Subject: Structural Investigation Report of the Roof for the Residence located at 10 Clear River Court, Sacramento, CA 95831.

re: Job 99148: Friedle residence located at 10 Clear River Court, Sacramento, CA

subject: Contract Change Order Number 1

ROOF PLAN - FRIEDLE

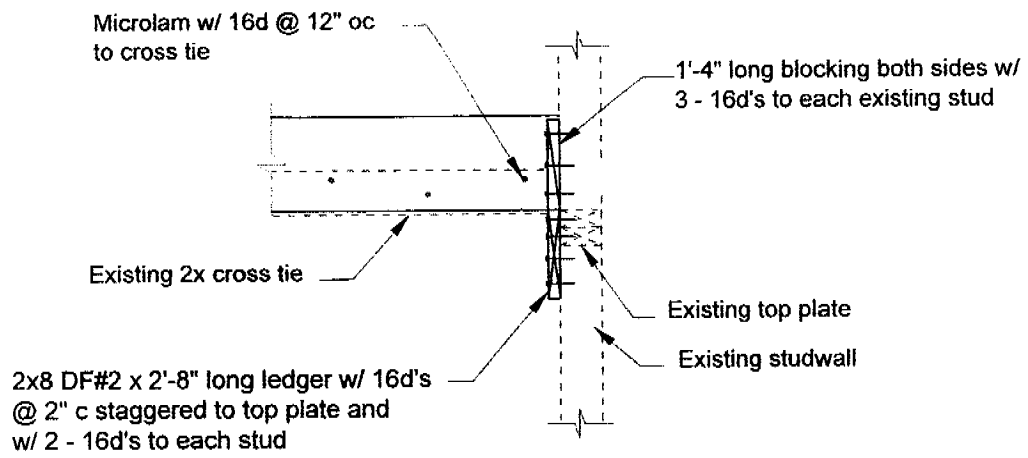
1. Scab a 1 3/4" x 11 7/8" microlam beam to the existing 2x6 crosstie and nail together with 16d's @ 12" oc. The end of the microlam may be clipped as required to meet the slope of the rafters. The support at the interior wall shall be a 2x8 x 2'-8" long ledger attached to the double top plate with 16d's @ 2" oc staggered. Support the ridge/ valley/ hip connection to the microlam beam or bearing wall below with 2x4 struts. The unbraced length of the struts shall not exceed 8'-0" and the minimum slope of the struts shall not be less than 45 degrees from the horizontal. See details 1 and 2.

LEDGER CONNECTION

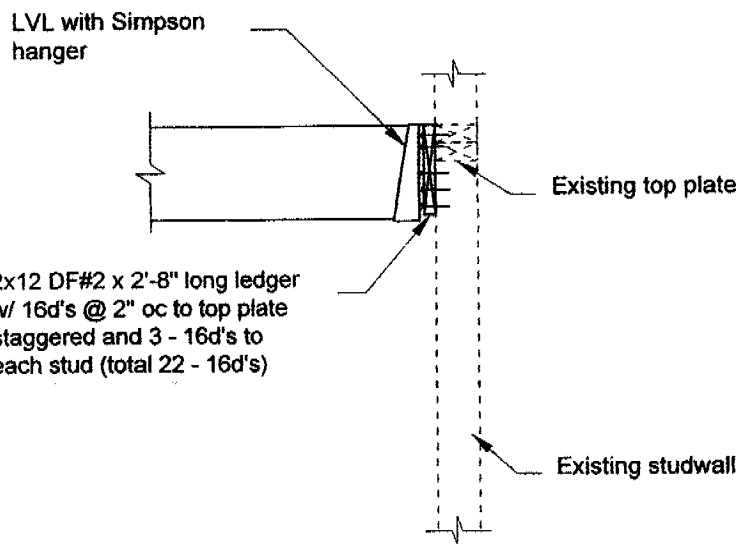
The microlam beam in the garage may be attached to the garage header and to the interior wall per the attached detail #1.
